**DOVER SCHOOL
DISTRICT**

JOINT BUILDING COMMITTEE – DOVER HIGH SCHOOL AND REGIONAL CTC MEETING NOTICE

Meeting Type:	Regular Meeting
Meeting Location:	Superintendent's Conference Room, McConnell Center
Meeting Date:	Tuesday, November 29, 2016
Meeting Time:	4:30 P.M.

Change Request Proposal 190006R1

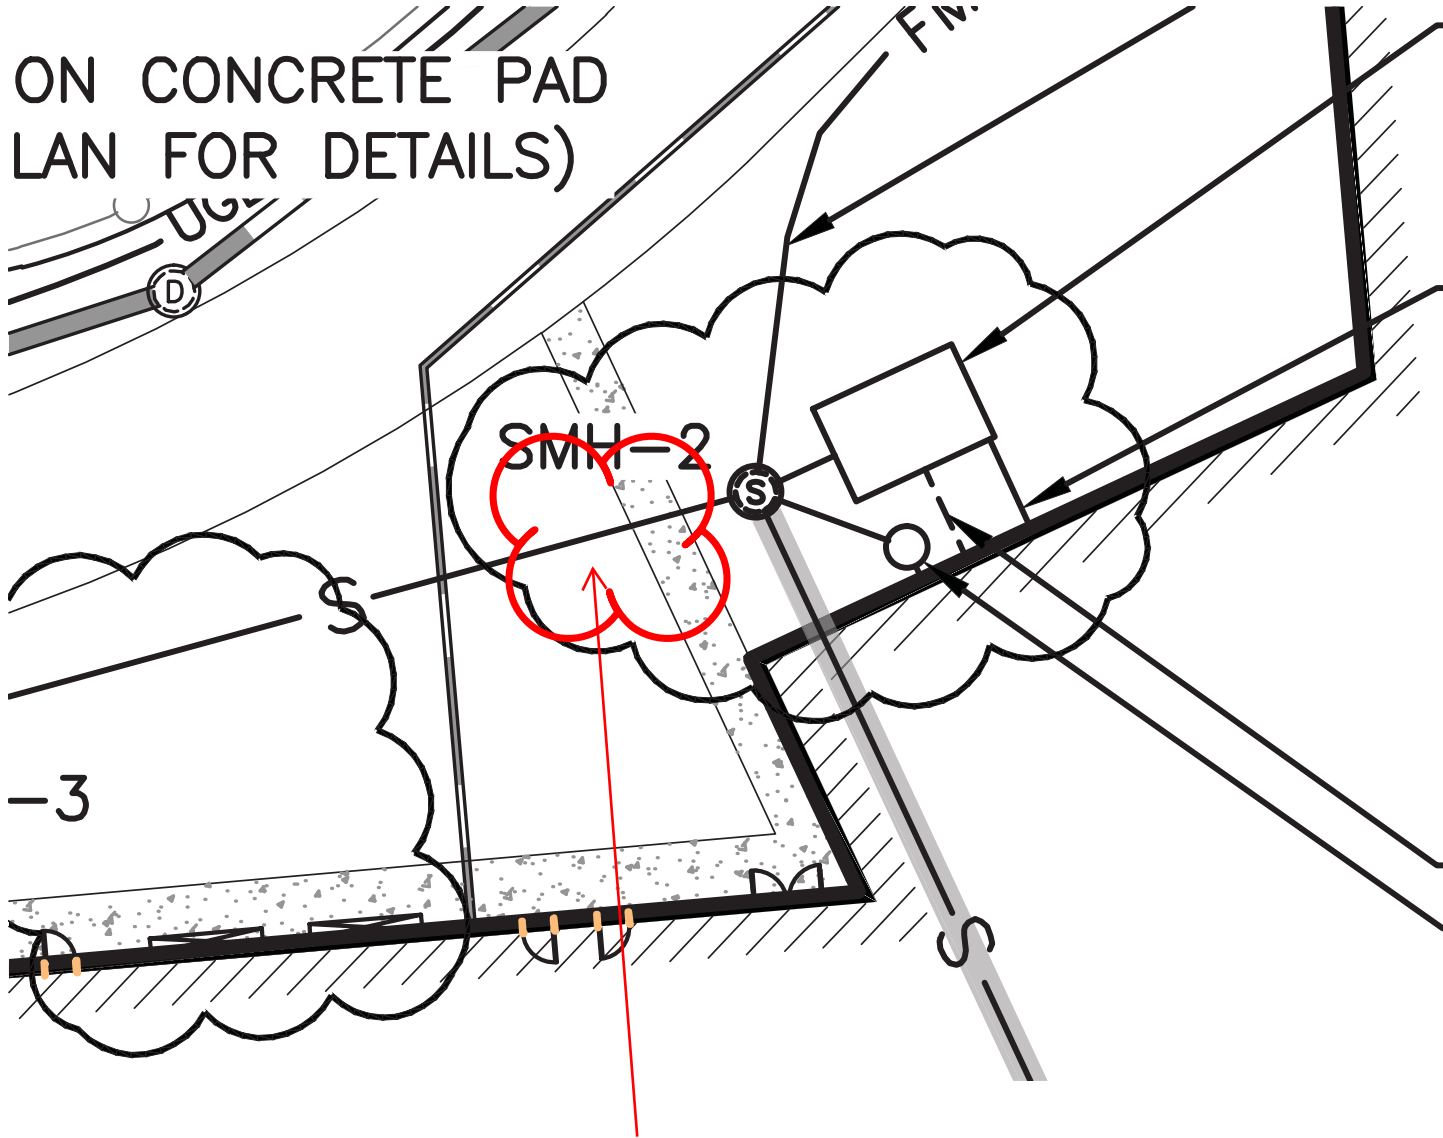
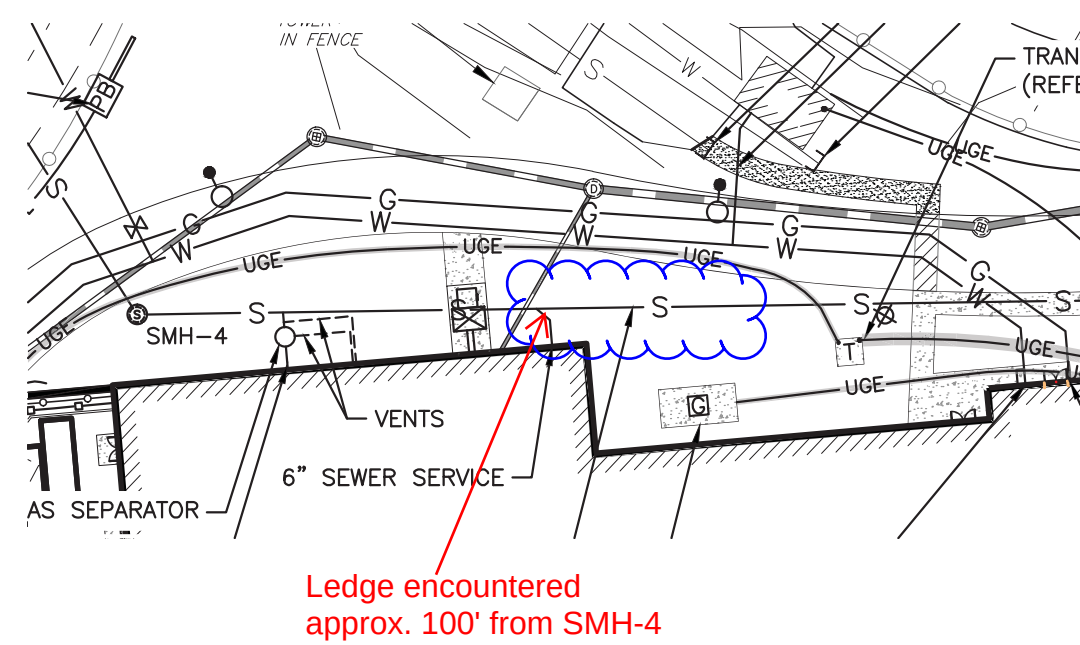
This proposal covers the additional costs to remove ledge for sewer line installation along the north side of the building between SMH-4 and SMH-2. See attached sketch for approximate location. Note additional ledge was removed to allow installation of the water line below the sewer as directed by Dover Community Services. This proposal has been revised to include mark-up as it is not included in the GMP.

In accordance with my contract for services, I have reviewed this change proposal and agree that it appears to be fair, reasonable, necessary, and consistent with the design intent. I hereby recommend acceptance.

Change Request Proposal 190012R1

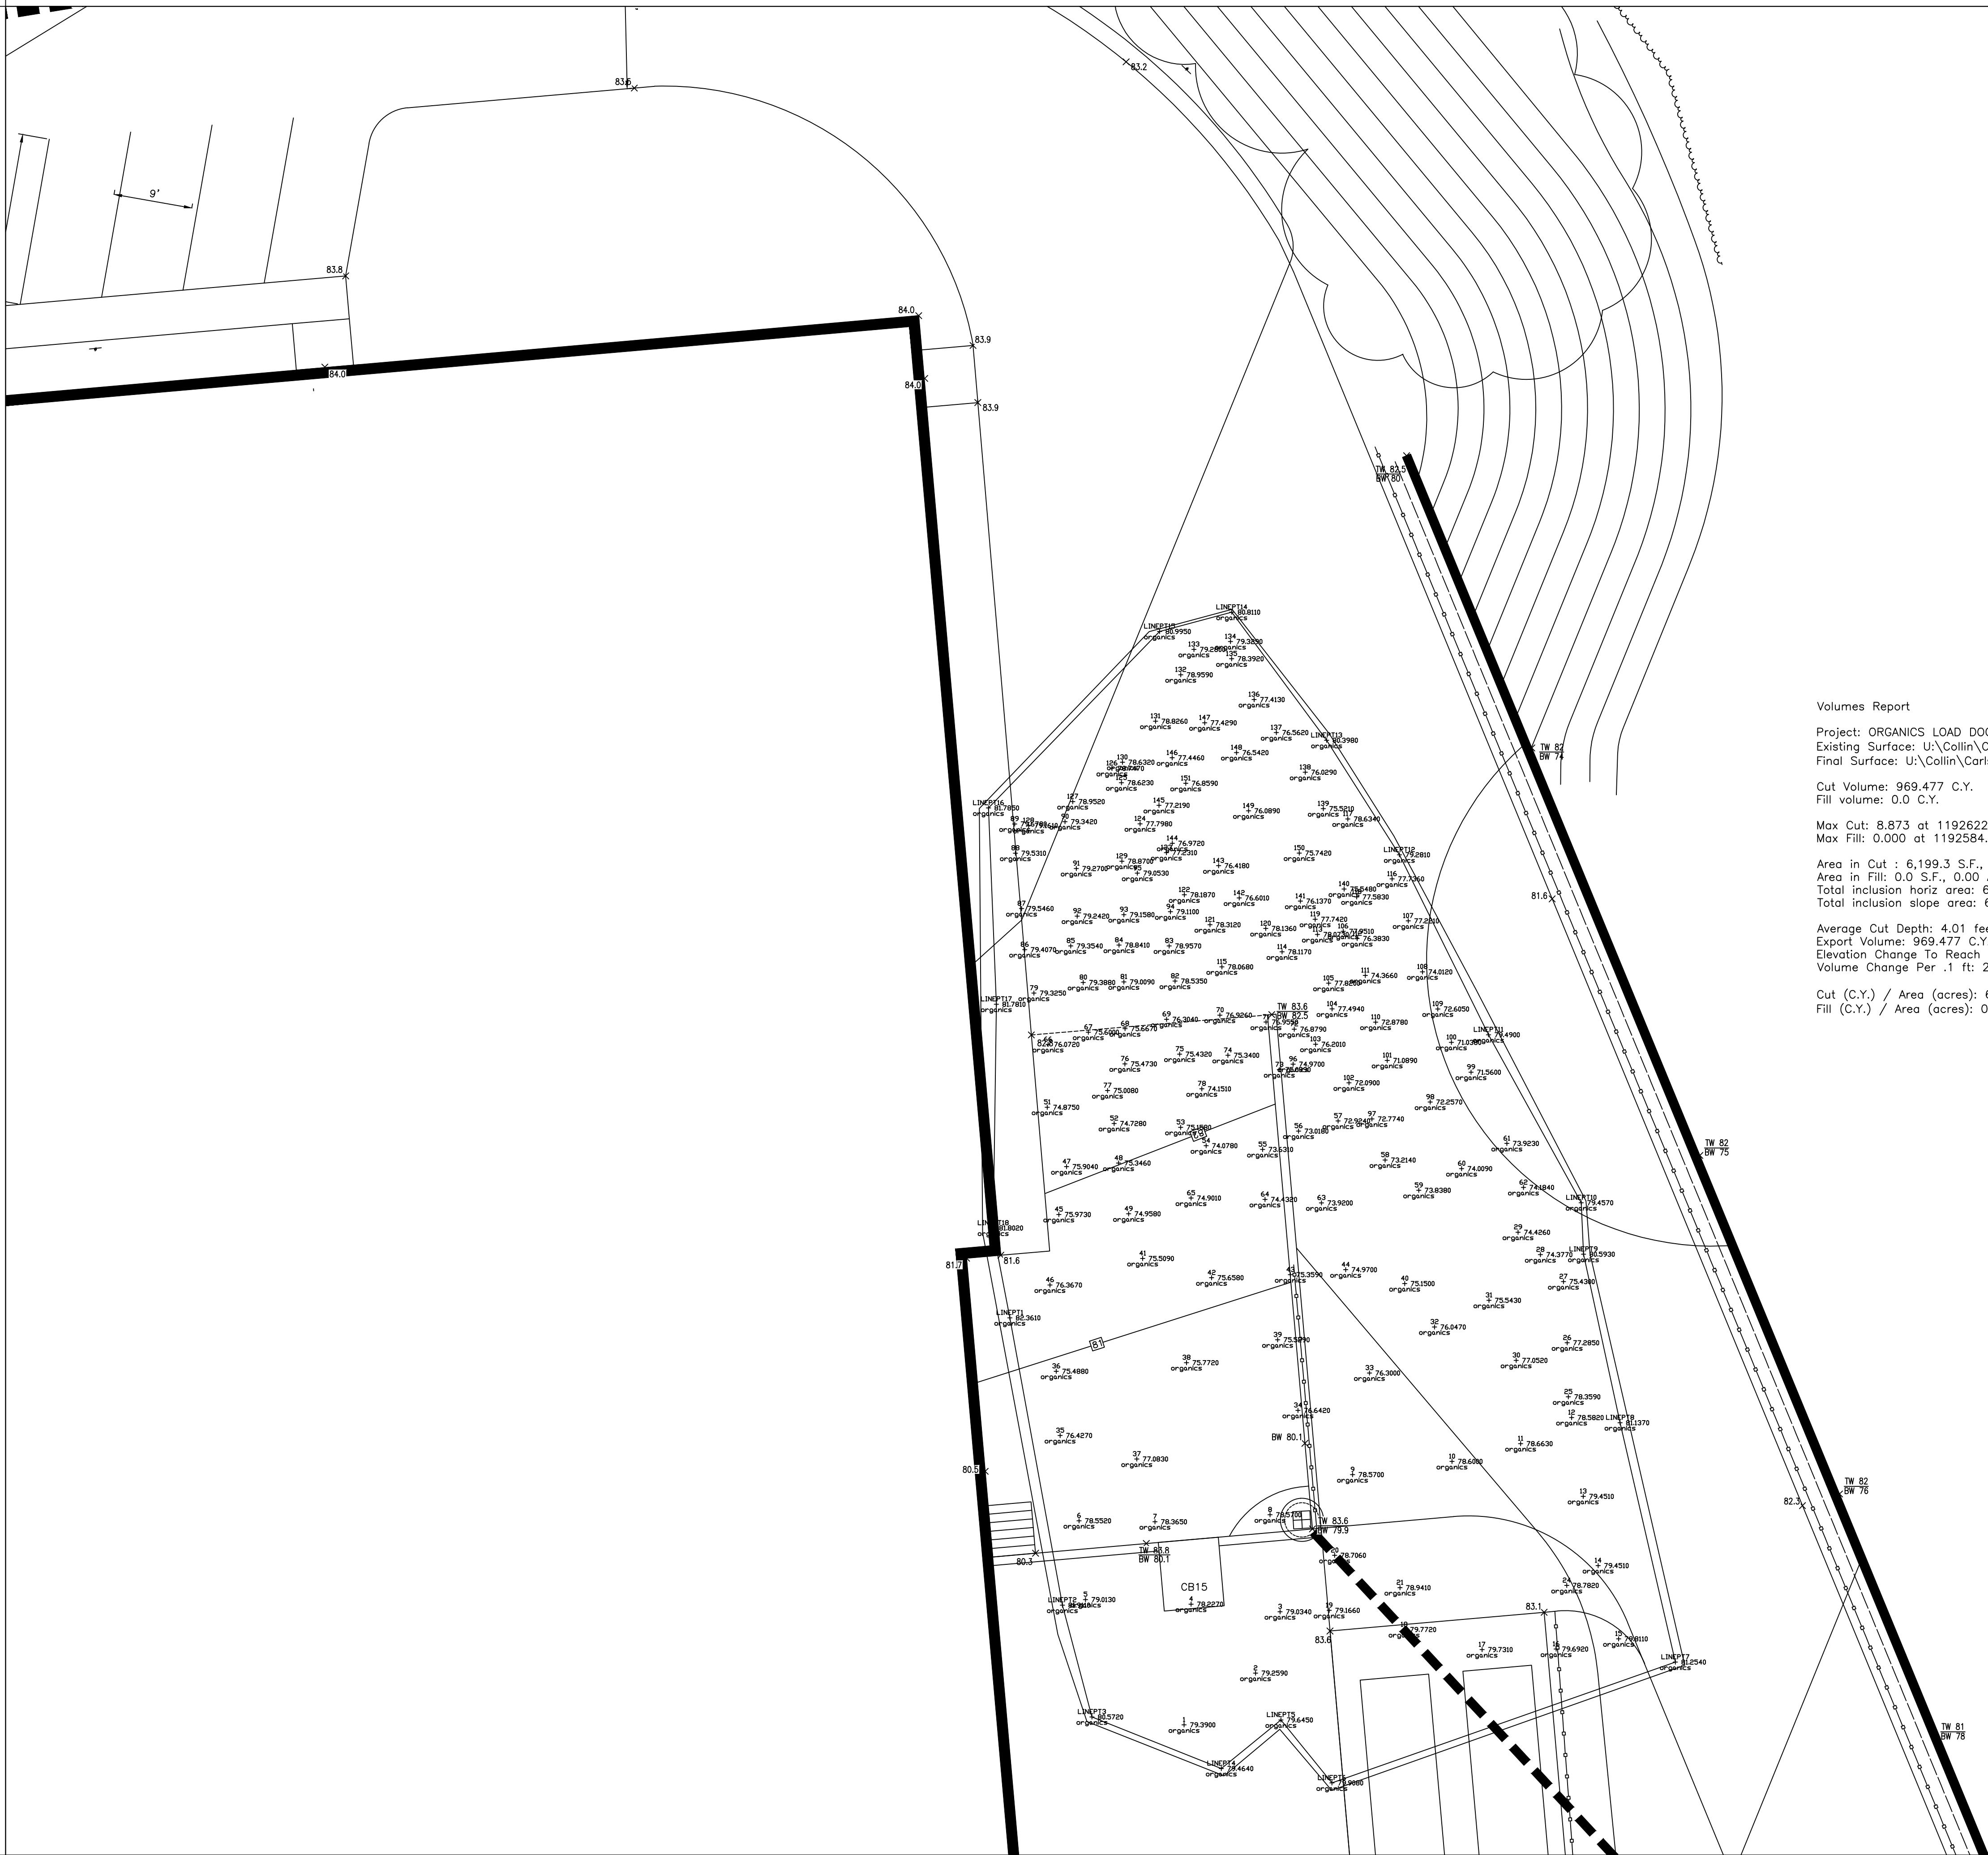
This proposal covers the additional costs to remove unsuitable organic materials encountered while excavating at the loading dock and driveway area as noted in RFI-009. Proposal includes removal and disposal of unsuitable materials and backfill with gravel borrow material. A layer of geotextile fabric was placed between the remaining clay/organic layer and the new backfill material. This proposal has been revised to include mark-up as it is not included in the GMP.

In accordance with my contract for services, I have reviewed this change proposal and agree that it appears to be fair, reasonable, necessary, and consistent with the design intent. I hereby recommend acceptance.

Change Request Proposal 190013R1

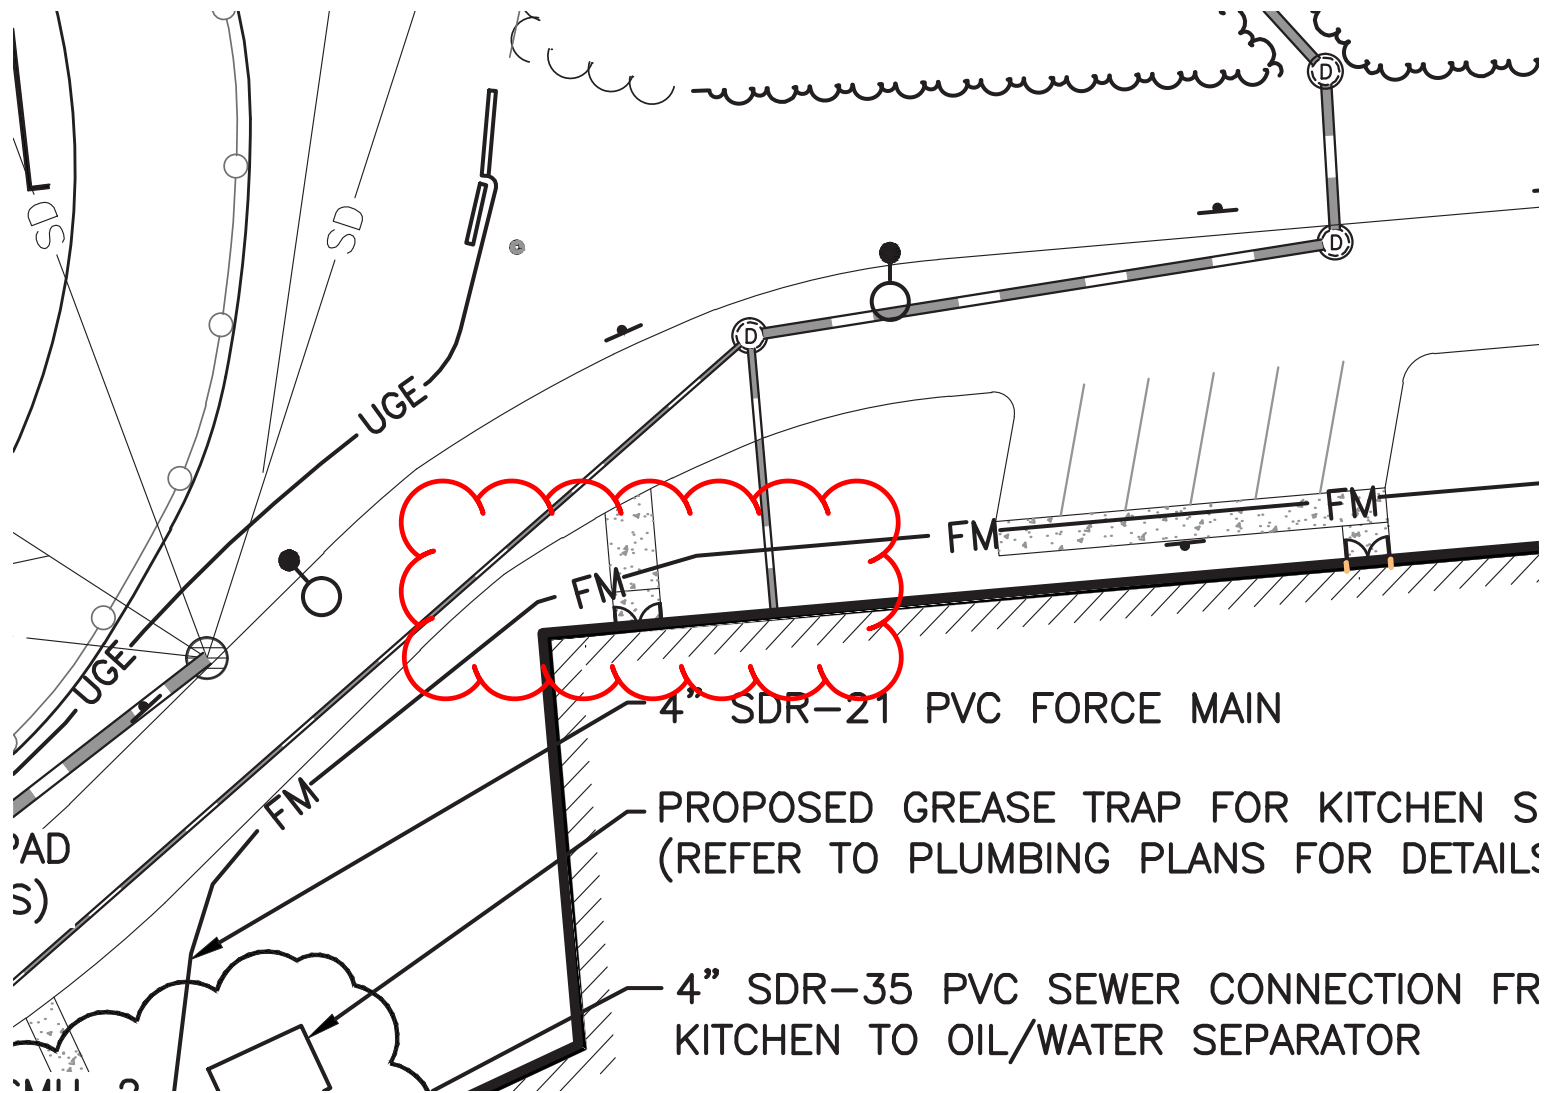
This proposal covers the additional costs to remove ledge at the NE corner of the gymnasium to allow installation of the force main from the middle school. See attached sketch for approximate location of ledge removal. The proposal has been revised to include mark-up as it is not included in the GMP.

In accordance with my contract for services, I have reviewed this change proposal and agree that it appears to be fair, reasonable, necessary, and consistent with the design intent. I hereby recommend acceptance.

Change Request Proposal 190014R1

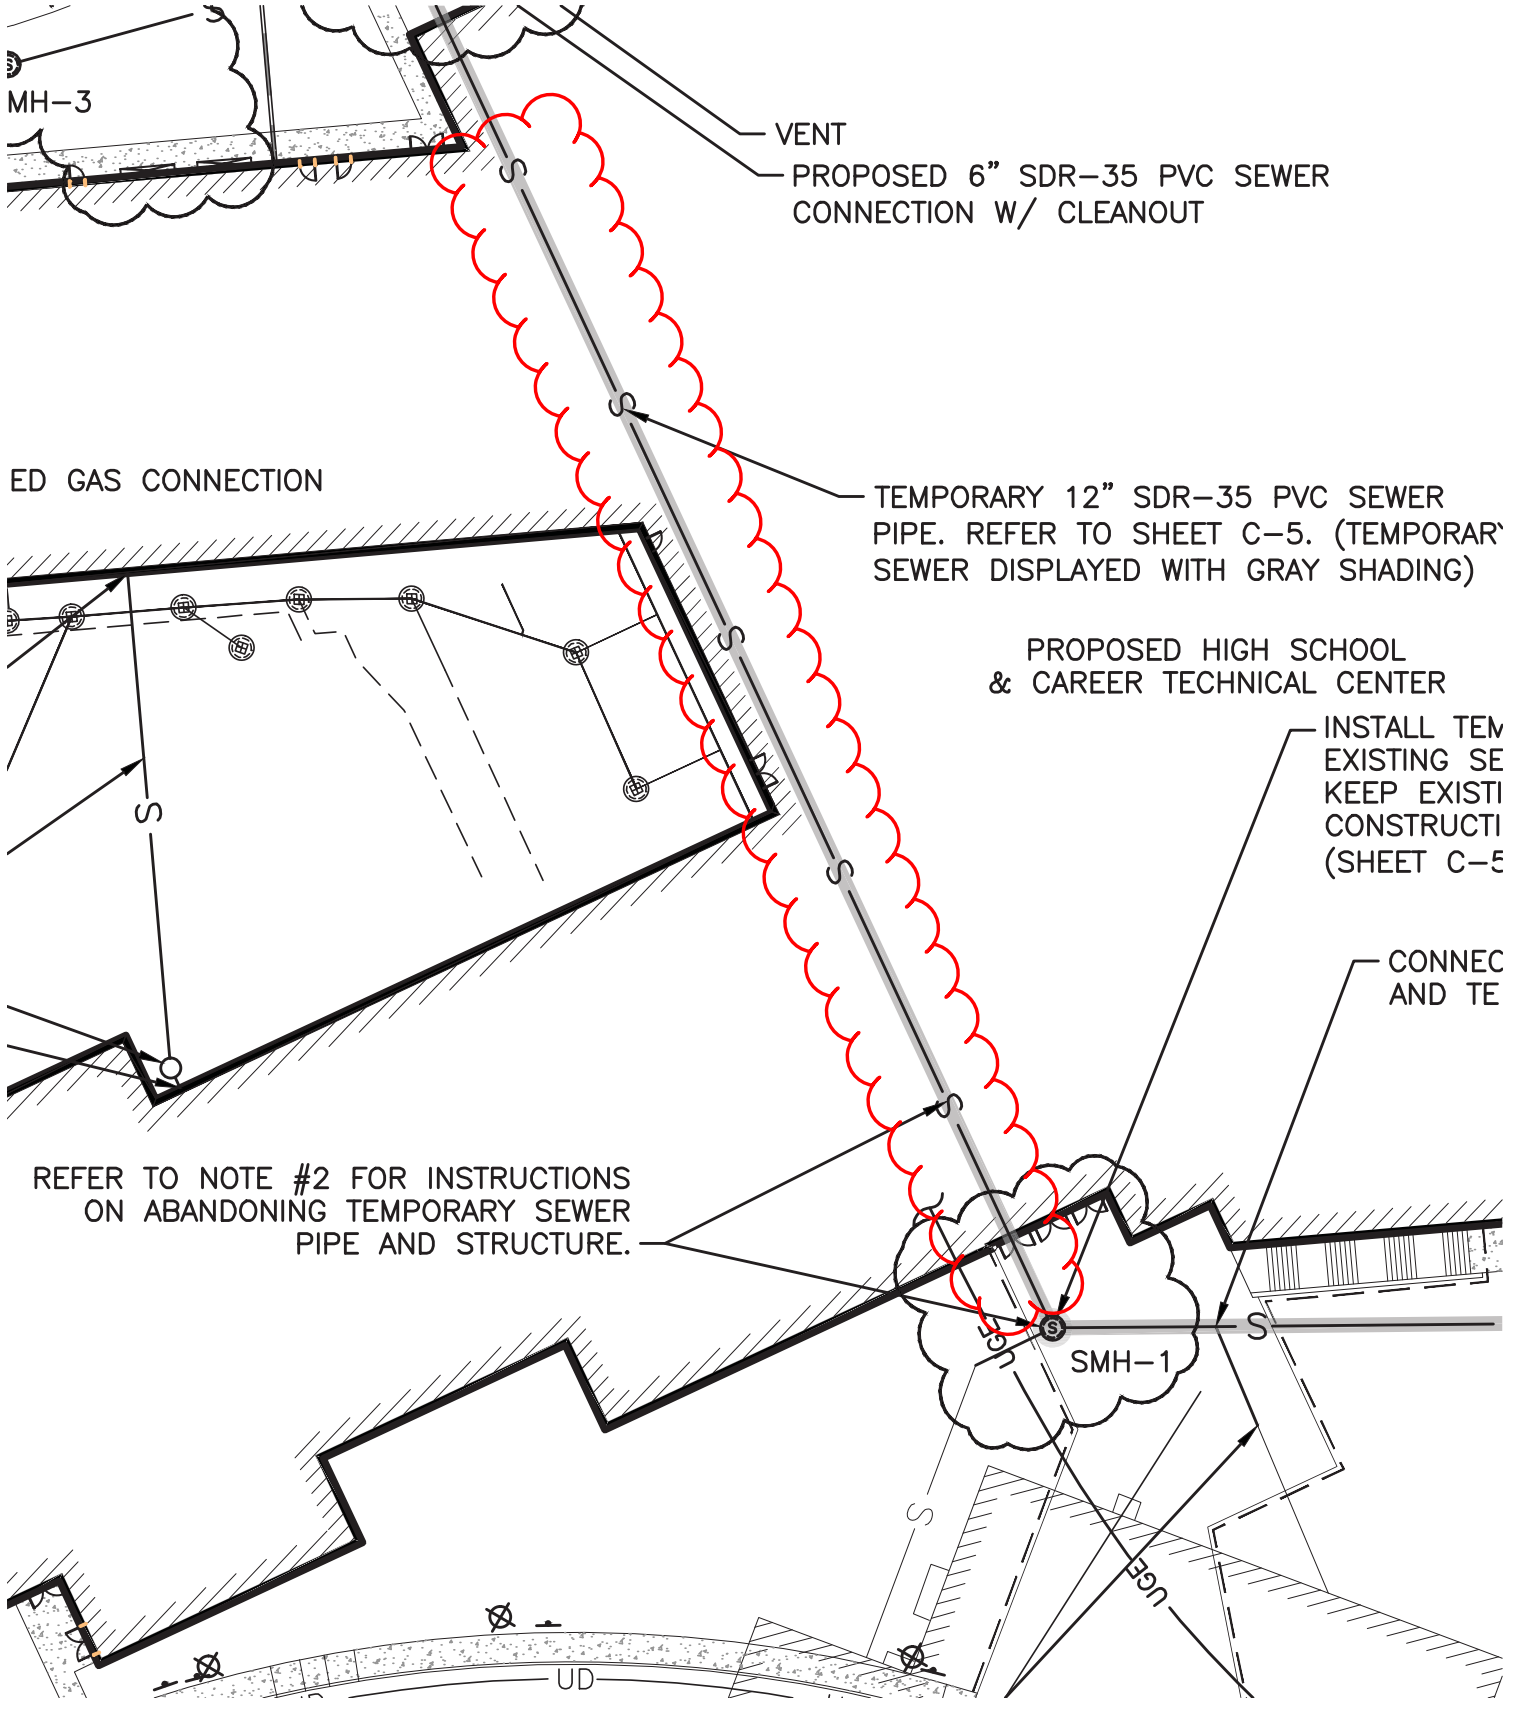
This proposal covers the additional costs for ledge removal required to install sewer structures SMH-2 and SMH-1 as well as the piping between. See attached sketch for approximate location of ledge removal. This proposal has been revised to include mark-up as it is not included in the GMP.

In accordance with my contract for services, I have reviewed this change proposal and agree that it appears to be fair, reasonable, necessary, and consistent with the design intent. I hereby recommend acceptance.
